SM 5 BSZ - Modifications to the TS 700  
(July 2 1997)

## SM 5 BSZ - Dynamic Range of 2 m Transceivers Part 2: Modifications to the TS 700

Published in VHF communications Nr 2 1982.

Fig. 1: In the TS700 the noise sidebands are caused by 600 Hz pulses from the DC converter. Massive lines = 4 different transceivers in their original states; broken lines = after modification

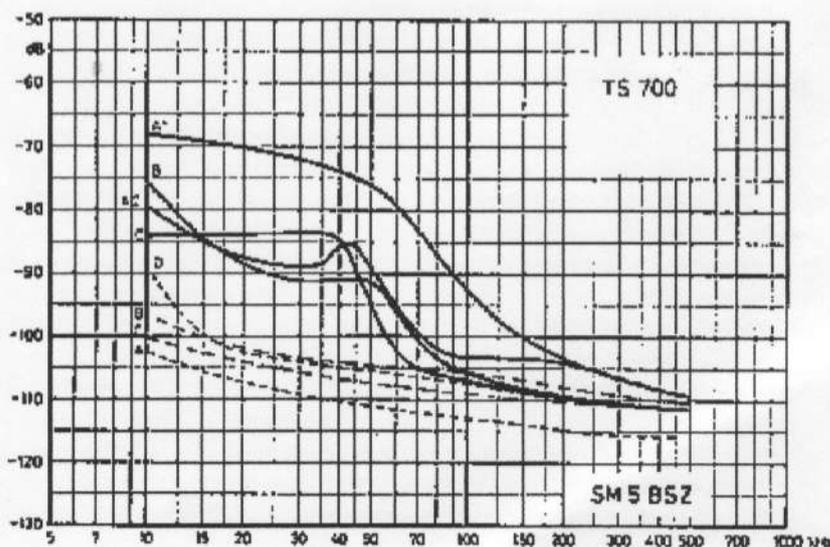
Figure 1 shows the noise sidebands of some TS700 transceivers before modification (continuous lines), and after modification (dashed lines).

The curves designated with "A" are from an older unit, which was defective during the first measurement (A 1). The cause for this were loose nuts used for mounting the board in the power supply. After tightening the four nuts, the transceiver exhibited normal, typical values (A 2). After publishing this article in "Radio och Television" the author received a number of letters that indicated that many such transceivers have this problem.

Curves B and C are from transceivers of more modern construction. Transceiver D was only measured after modification; it is not known whether it is an older or newer model.

1. The first step in improving the interference sidebands of the TS700 is thus simple: Tighten these nuts so that the power supply has a good ground connection.

Fig. 2: These are the modifications:

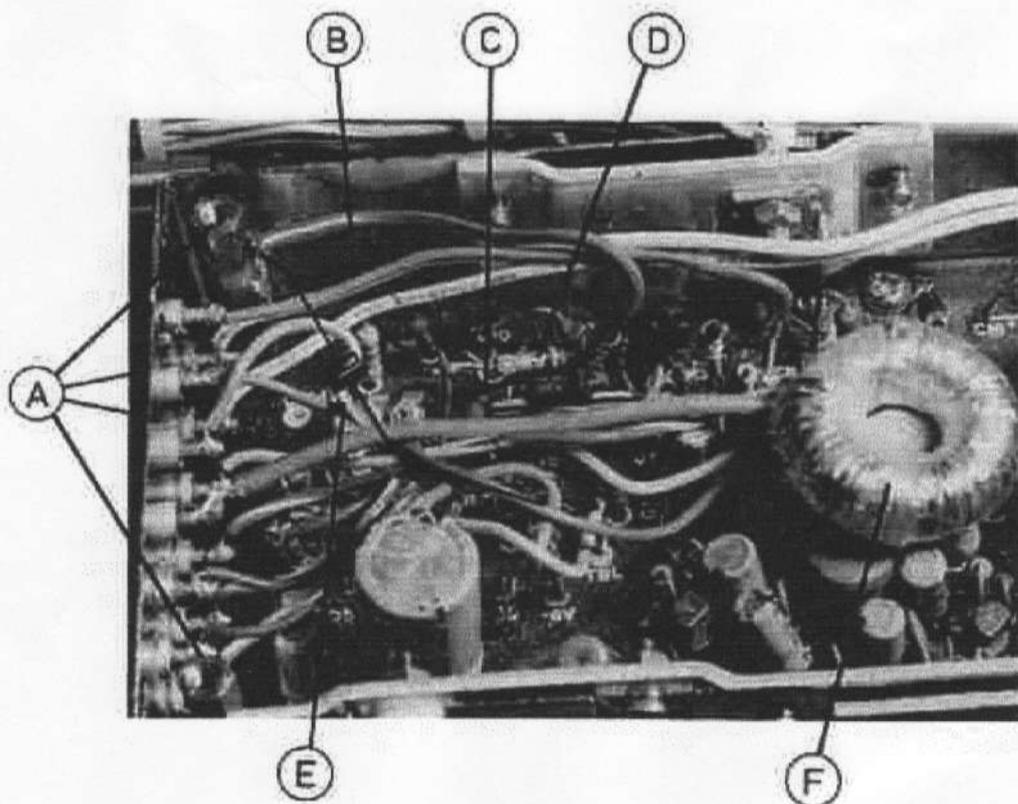
Very high currents of the 600 Hz spikes flow within the power supply. The selection of the ground points is therefore very critical. The ground points of the 9 V stabilizer have not been carefully selected, and for this reason, the second and third steps of the modifications are in improving the ground connections of the 9 V stabilizer circuit. These are carried out as follows:

Newer TS700 also require a further modification: Although steps 2 and 3 have reduced the AC-voltage on the 9 V line (especially at lower frequencies), the 9 V-voltage is still not clean enough, and it is necessary to carry out step 4.

2. The ground pin of the integrated stabilizer (Q11, pin 1) is connected to one of the previously mentioned nuts by connecting a copper wire of at least 2.5 mm diameter from the upper side of the IC to the nut, and soldering it into place. That nut should be used that is nearest to the 144 MHz power amplifier.

3. The ground end of R28 is now connected to pin 1 of Q11. The upper end of R28 is now cut and a new 1 kilohm resistor connected from the loose end of R27 to pin 1 of Q11 (from above).

A: Tighten all 4 bolts

B: Solder a heavy wire from the bolt in the upper left-hand corner to pin 1 of Q11

C: Cut the old resistor

D: Put in the new 1 kilohm resistor

E: This is where the 220 microfarad electrolytic capacitor finds its place

F: The toroid-core choke
